ADDENDUM NO. 2 TO PROJECT NO. 42535

PROVIDE ELECTRIC UPGRADE FOR FEEDERS, TRANSFORMERS, AND SWITCHGEAR SITEWIDE

GREENHAVEN CORRECTIONAL FACILITY
ROUTE 216
STORMVILLE, N.Y. 12582

February 21, 2013

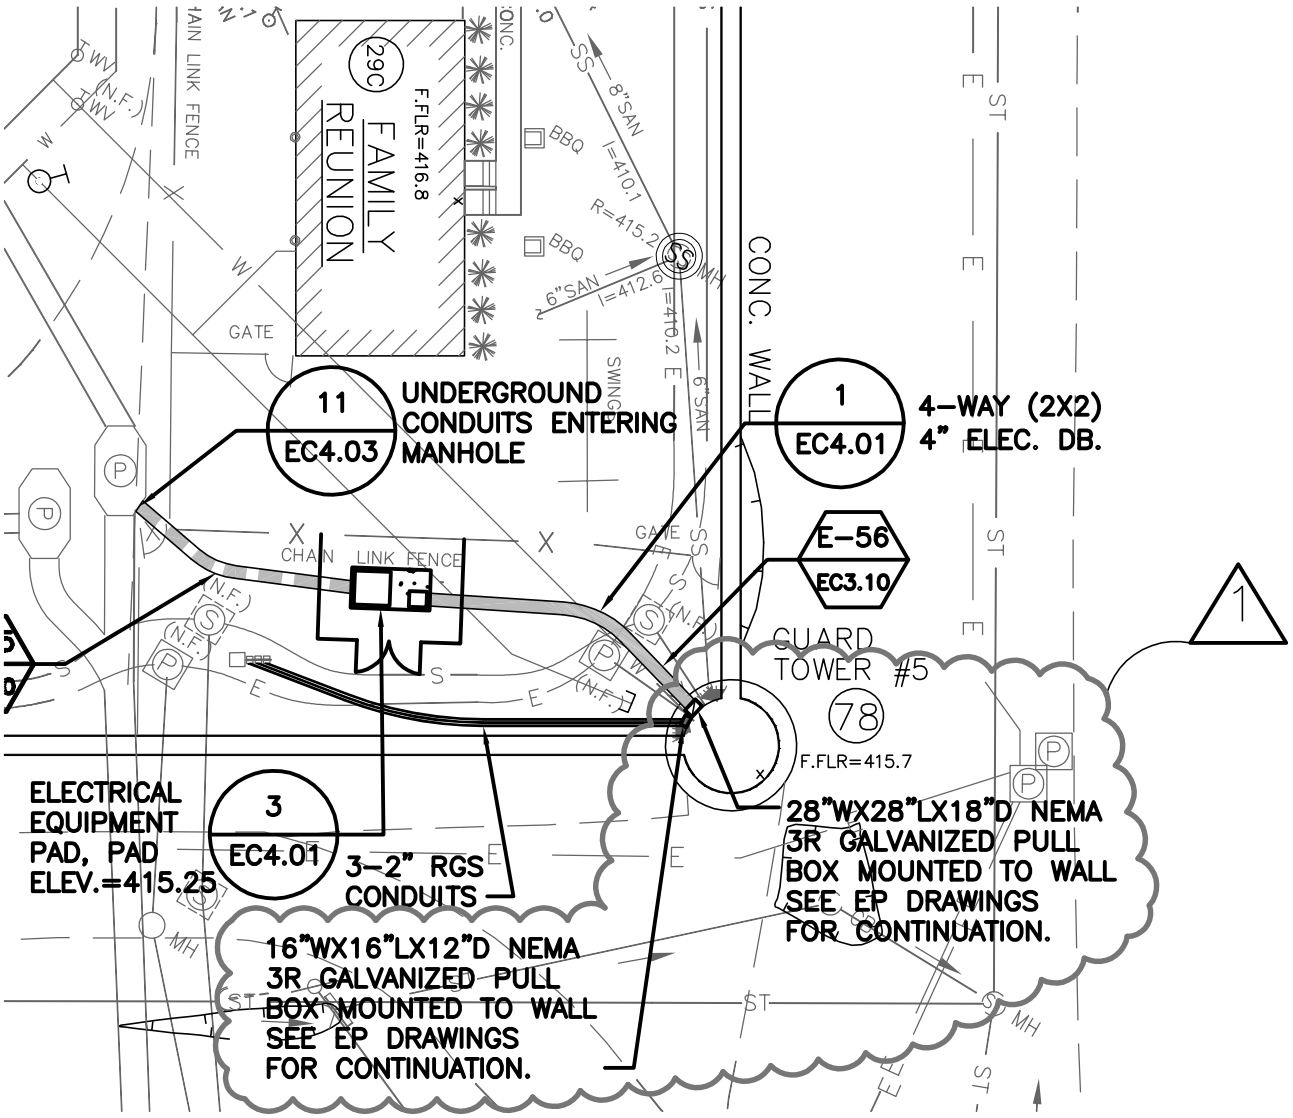
4. Drawing EC2.06:
   a. Revise the "UTILITY SITE PLAN – AREA 6". See accompanying sketch SK-EC2.06-1.
   b. Revise Building No. 22 – Gymnasium ductbank callout to read "6-WAY (3X2) 4" ELEC. DB."

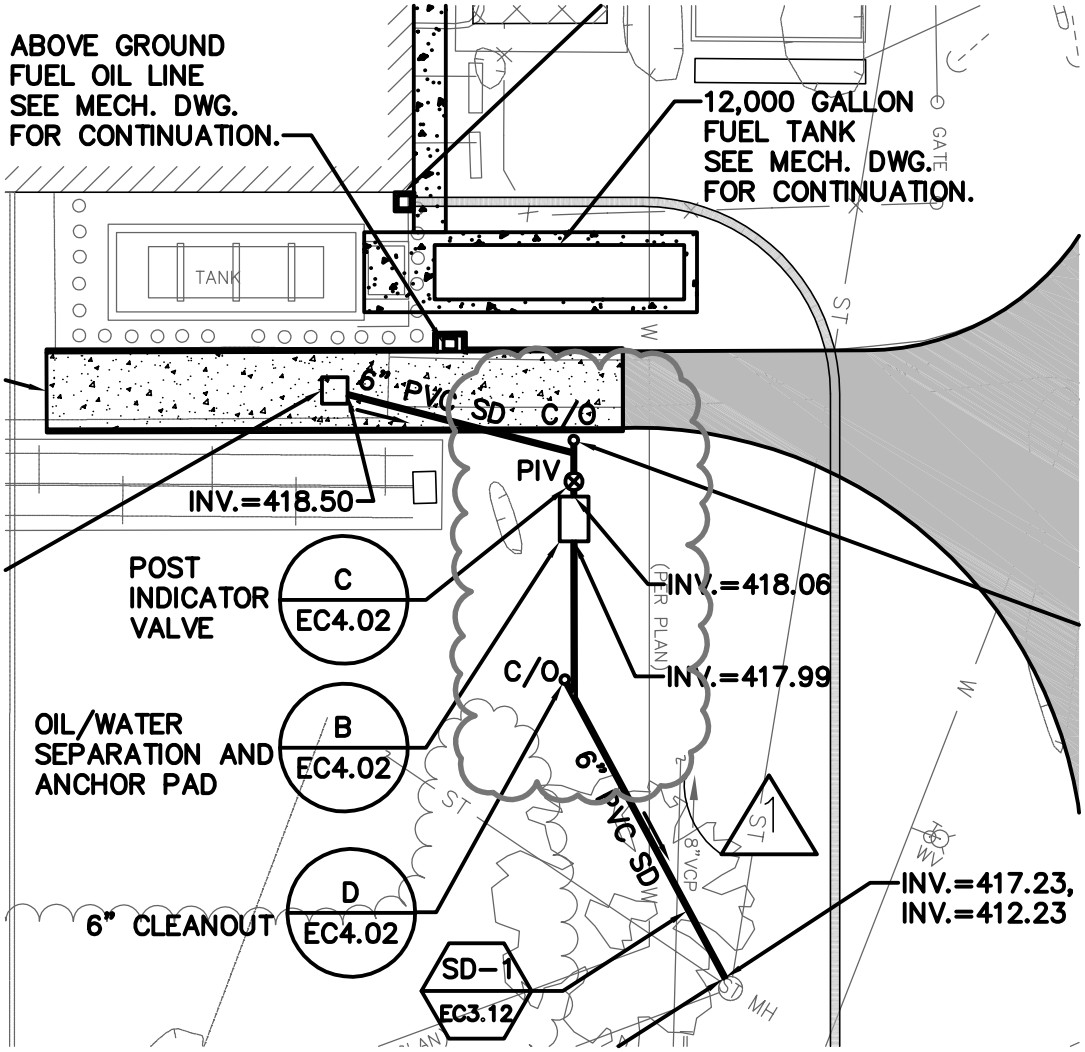
5. Drawing EC2.07:
   a. Revise the "UTILITY SITE PLAN – AREA 7". See accompanying sketch SK-EC2.07-1

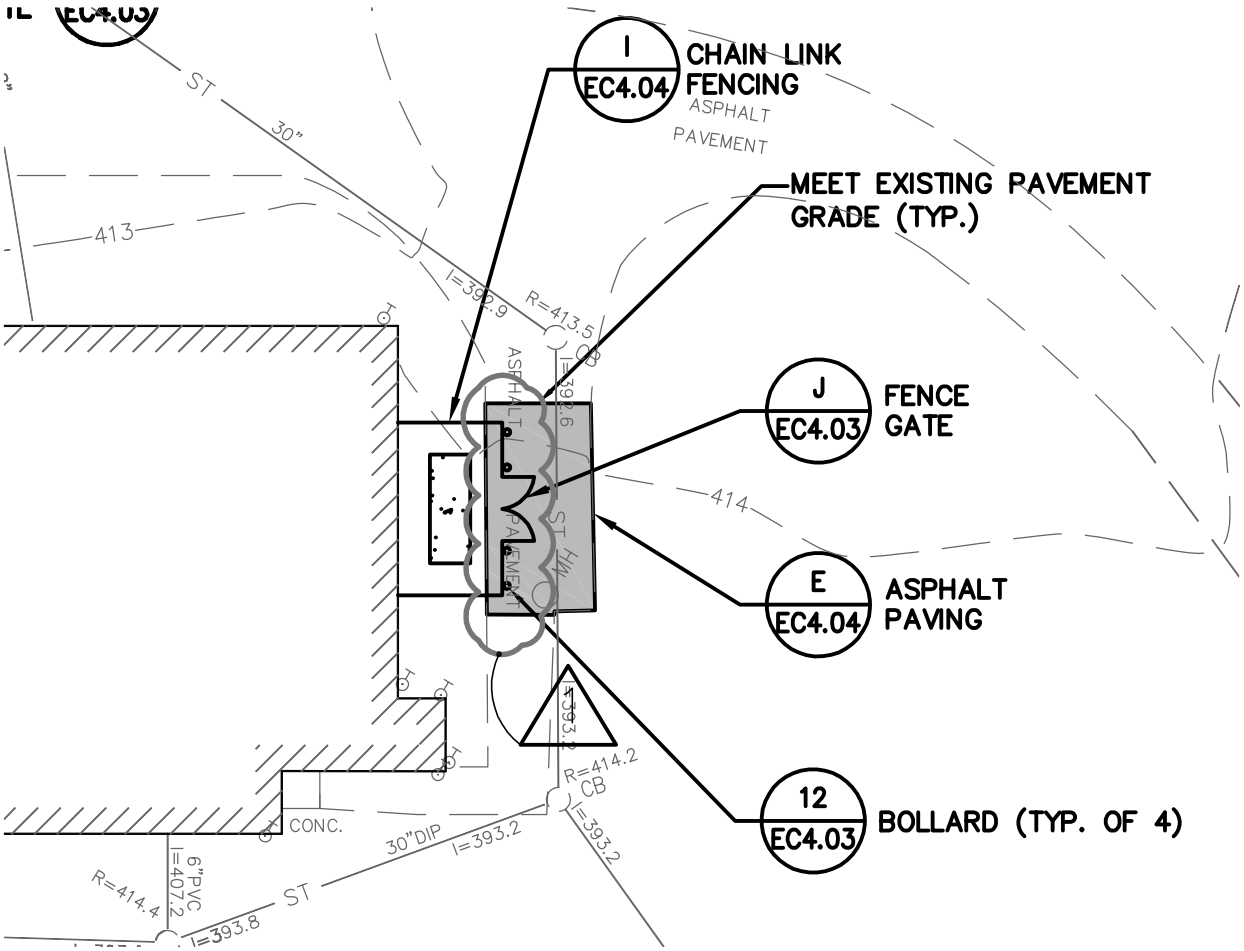
6. Drawing EC2.15:
   a. Revise the "RESTORATION PLAN – AREA 2". See accompanying sketch

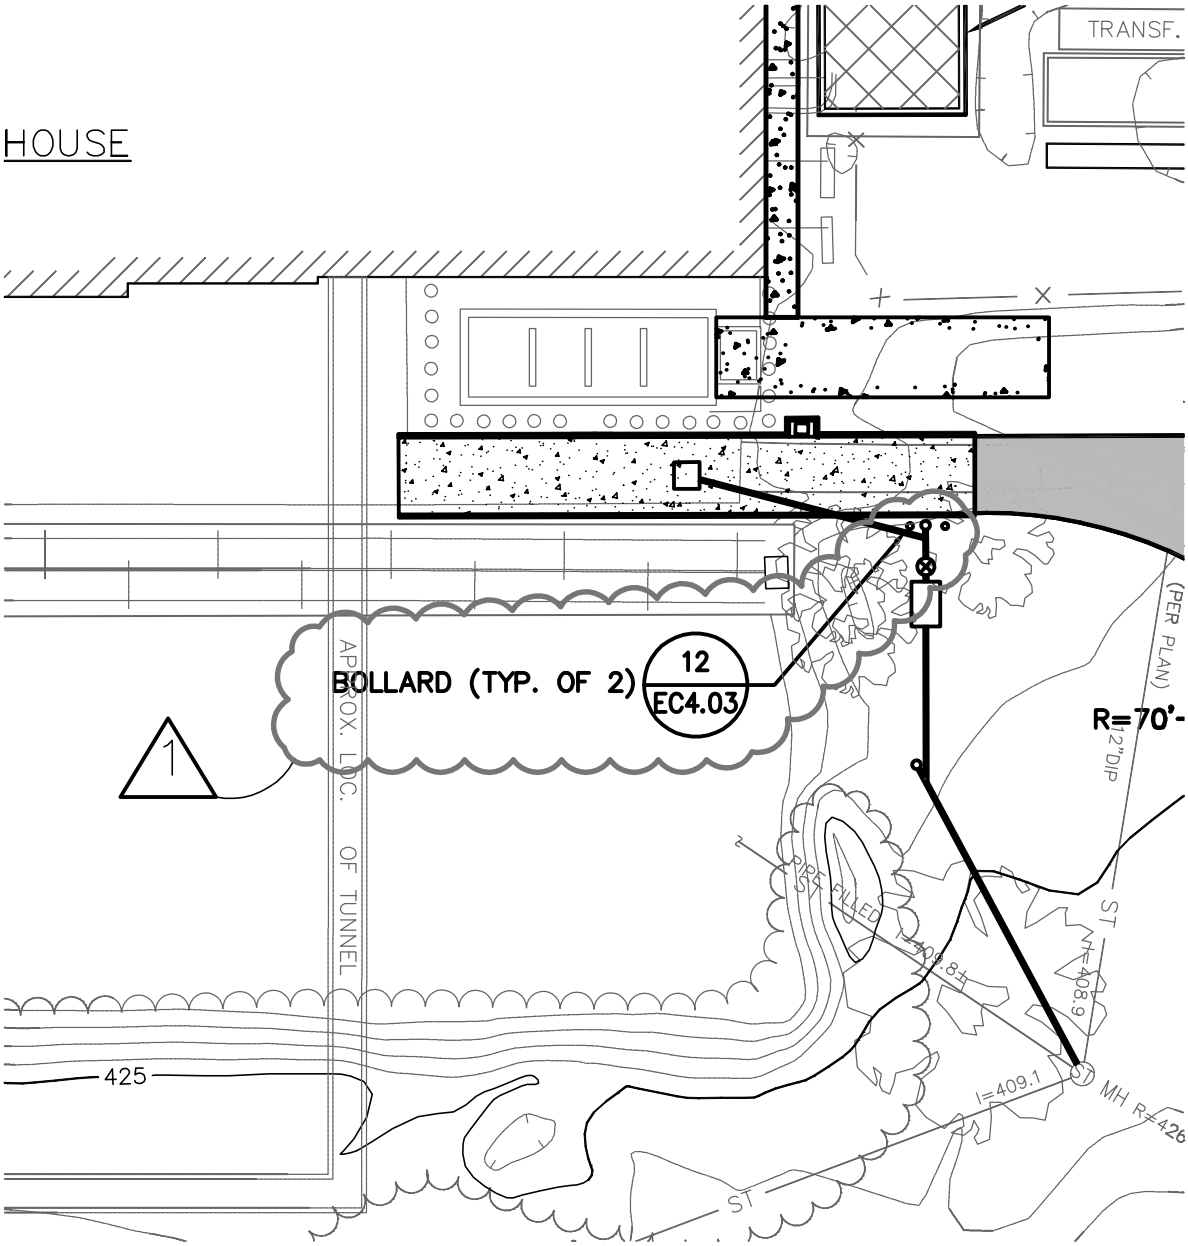
7. Drawing EC2.20:
   a. Revise the "RESTORATION PLAN – AREA 7". See accompanying sketch SK-EC2.20-1.

PROJECT NO:	SCALE:
111109.A0	AS SHOWN
DATE: 02/19/13	DWG NO: SK-EM1.12-1

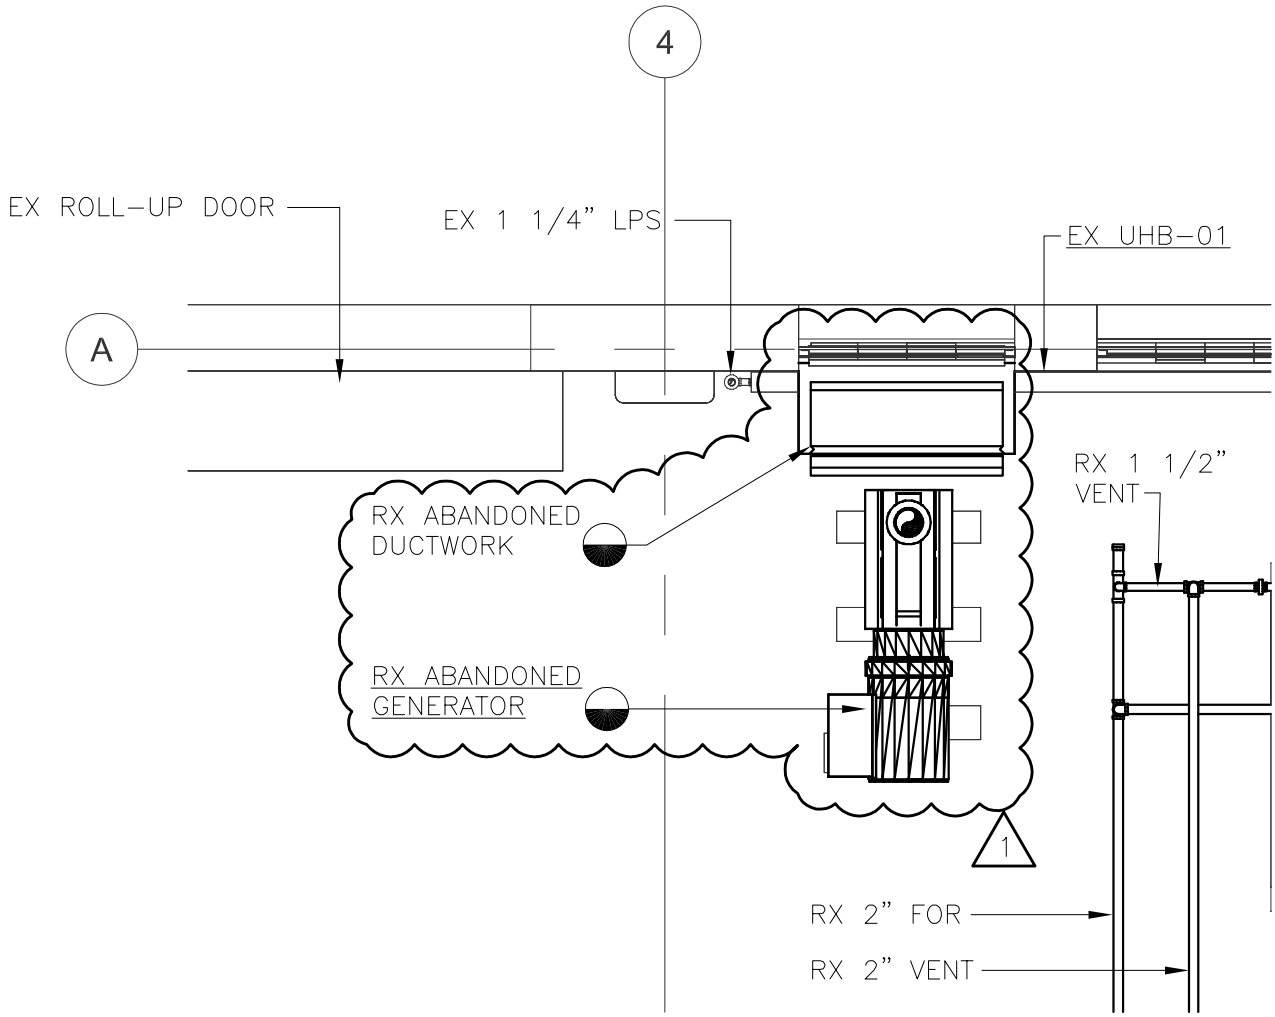
23. Drawing EM1.12:
    a. Existing abandoned generator removal scope was modified. See accompanying Sketch SK-EM1.12-1.

SHEET TITLE:
ENGINE ROOM – UPPER LEVEL ELEV. 437.0' – REMOVALS – PH 1

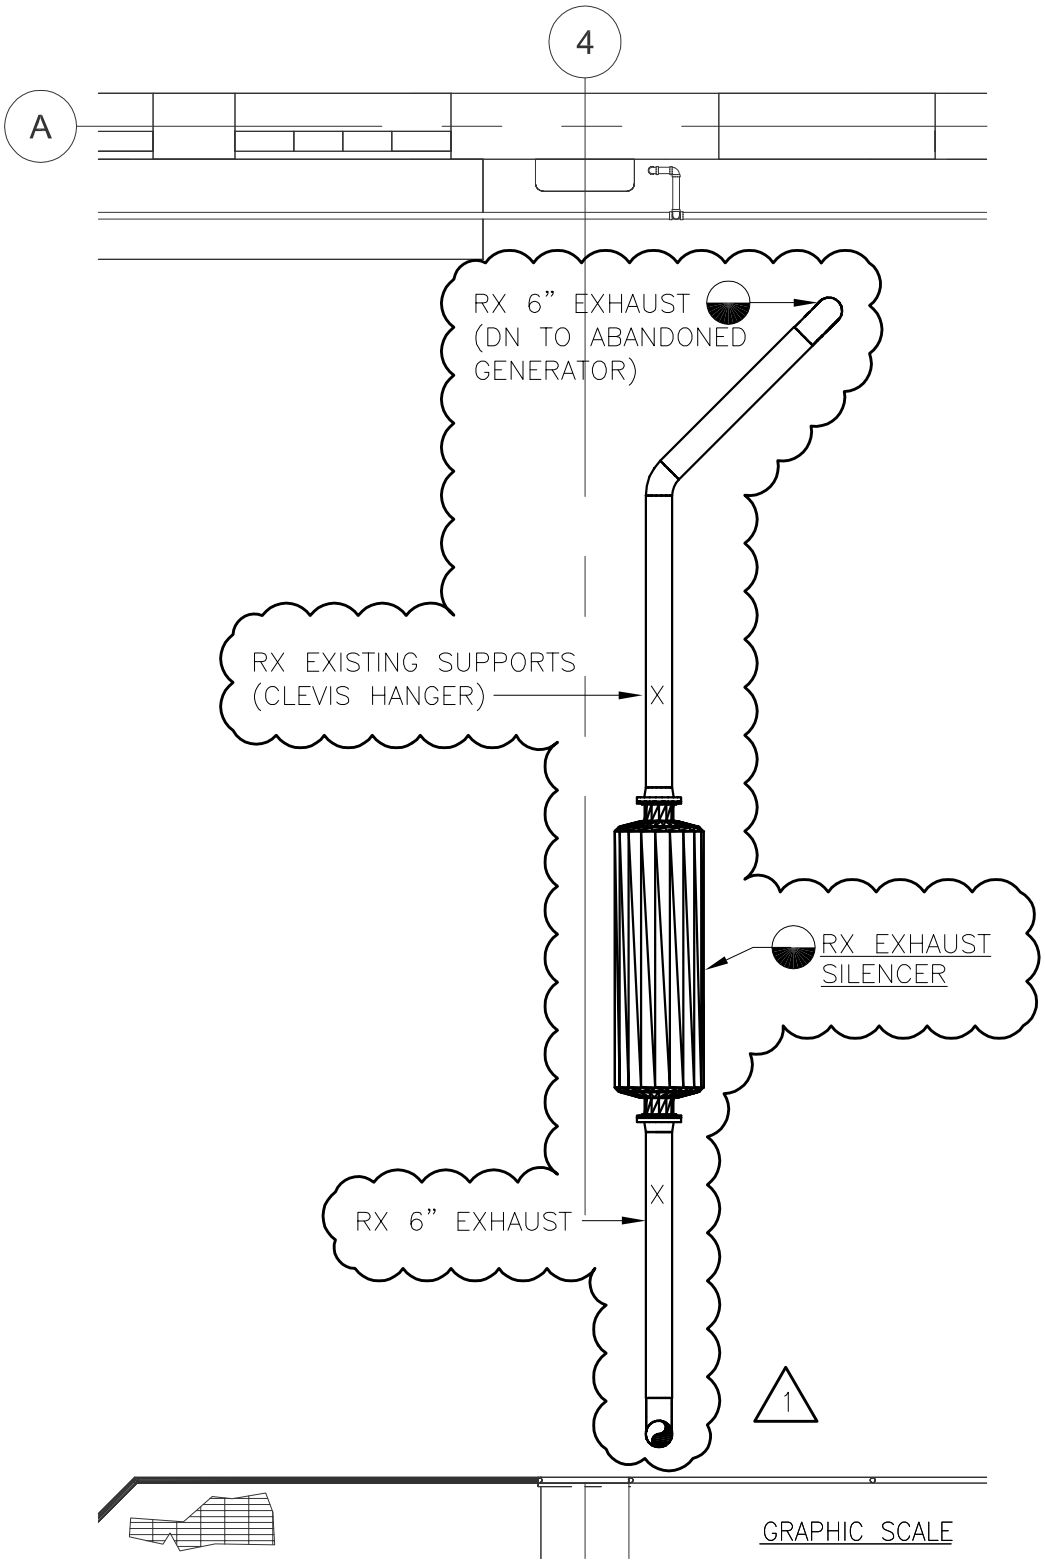
24. Drawing EM1.13:
    a. Existing abandoned generator exhaust pipe and silencer removal scope was modified. See accompanying Sketch SK-EM1.13-1.

PROJECT NO:	SCALE:
111109.A0	AS SHOWN
DATE: 02/19/13	DWG NO: SK-EM2.22-1

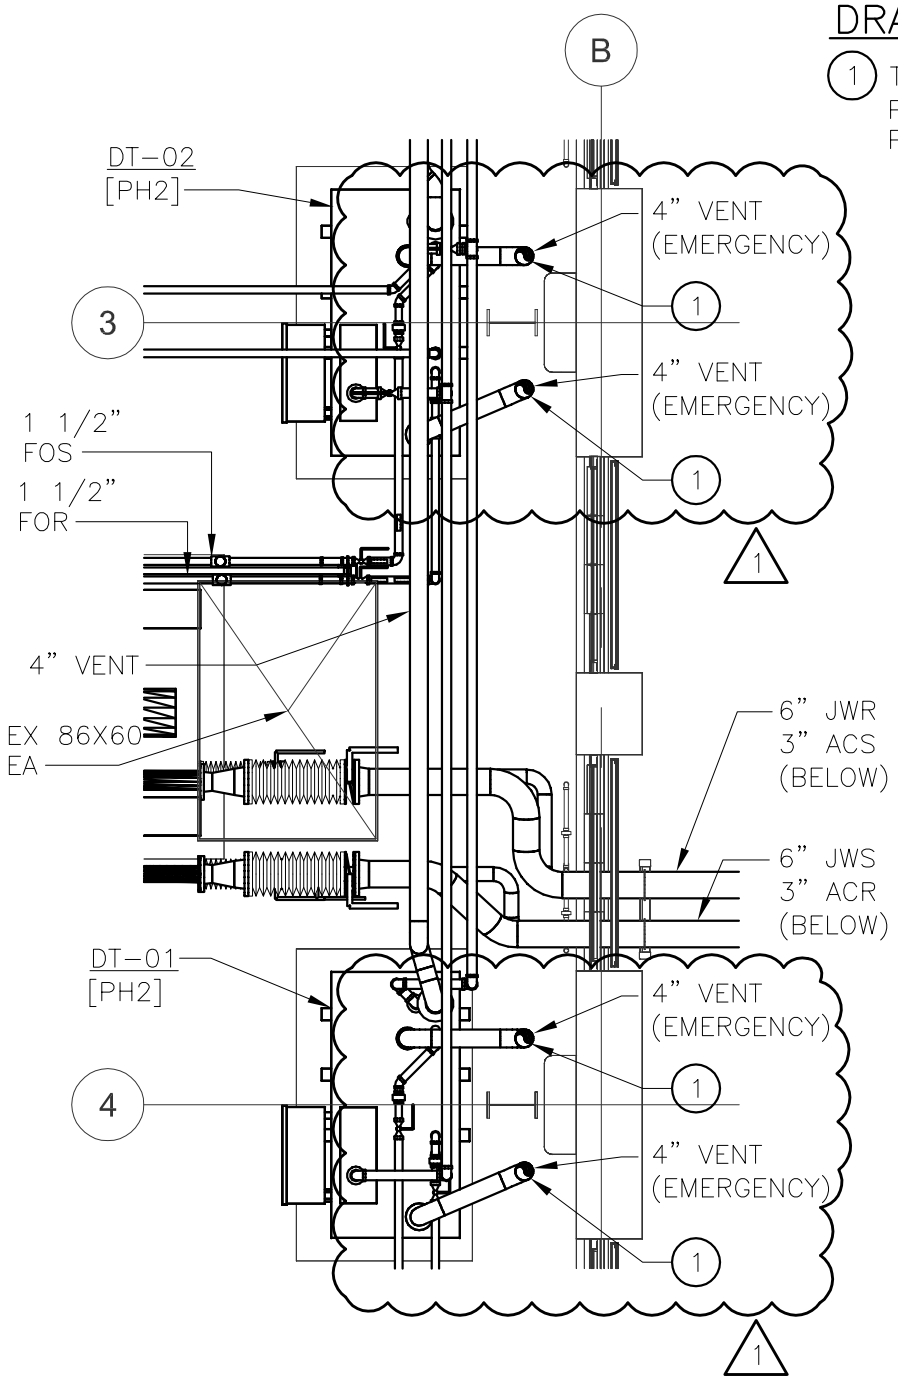
26. Drawing EM2.22:
    a. Two, 4", emergency vents were added to each day tank. One vent serves the main storage and the second vent serves the interstitial space. These vents are required for UL142 and NFPA 30 compliance. The vents are routed up through the roof and capped with an approved pressure vent cap. See accompanying Sketch SK-EM2.22-1.

1. TERMINATE EMERGENCY VENT PIPE 3' ABOVE ROOF LEVEL. PROVIDE EMERGENCY VENT CAP.

PROJECT NO:	SCALE:
111109.A0	AS SHOWN
DATE: 02/19/13	DWG NO: SK-EP2.10B-1

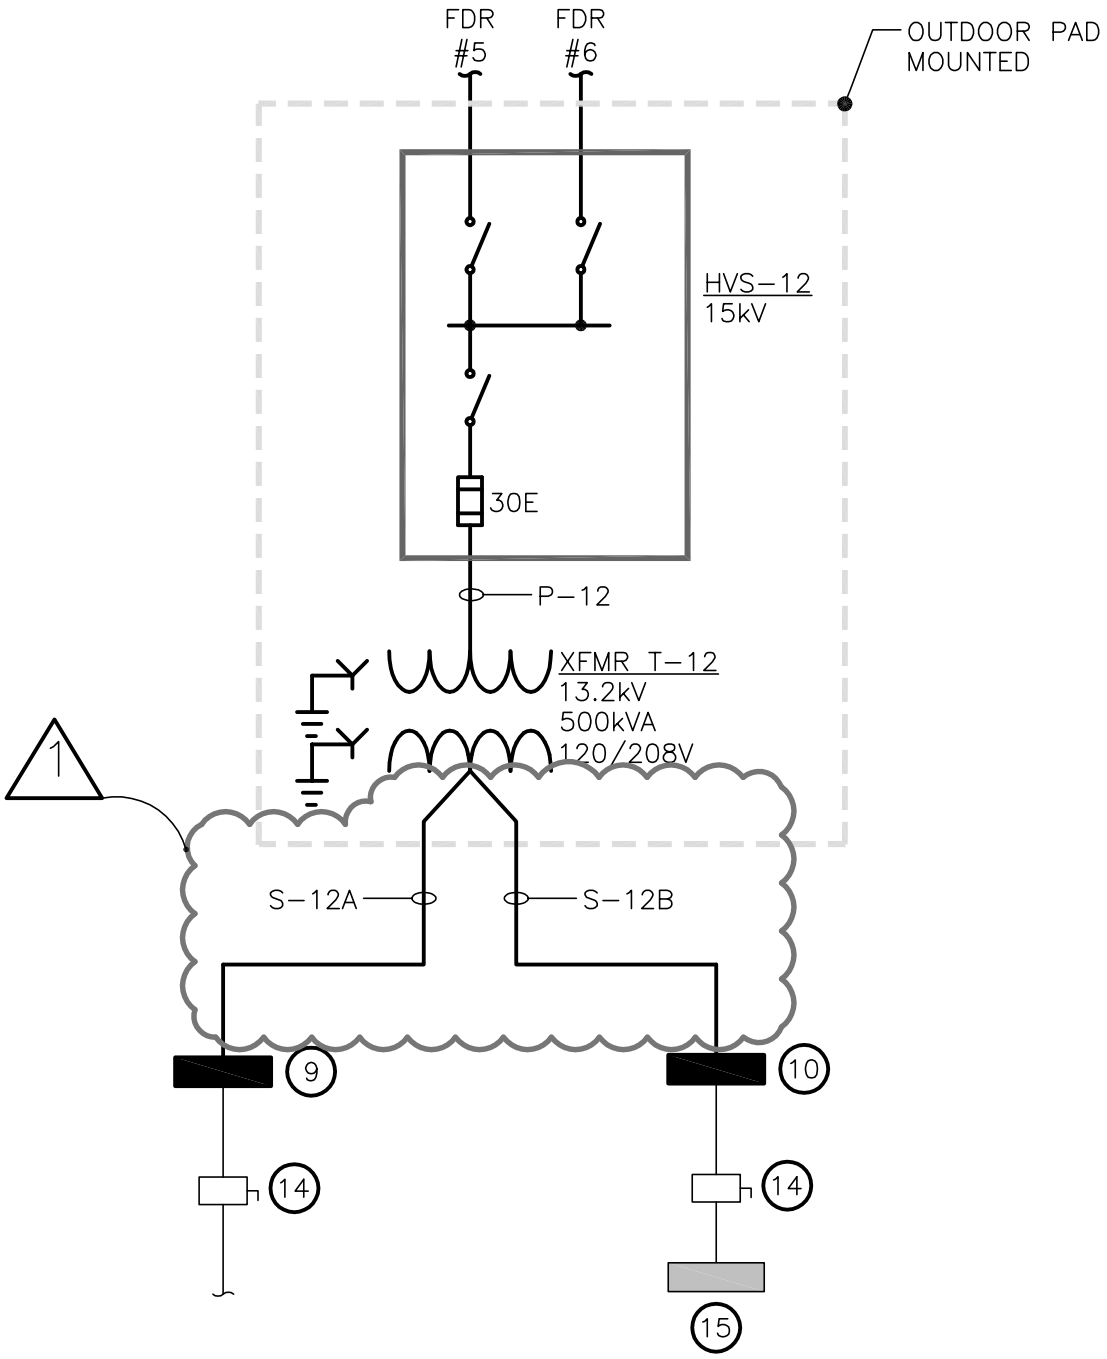
14. Drawing EP2.10B:
    a. Revise "GREEN HAVEN C.F. – VOCATIONAL SCHOOL BUILDING No. 12 – NEW WORK". See accompanying sketch SK-EP2.10B-1.
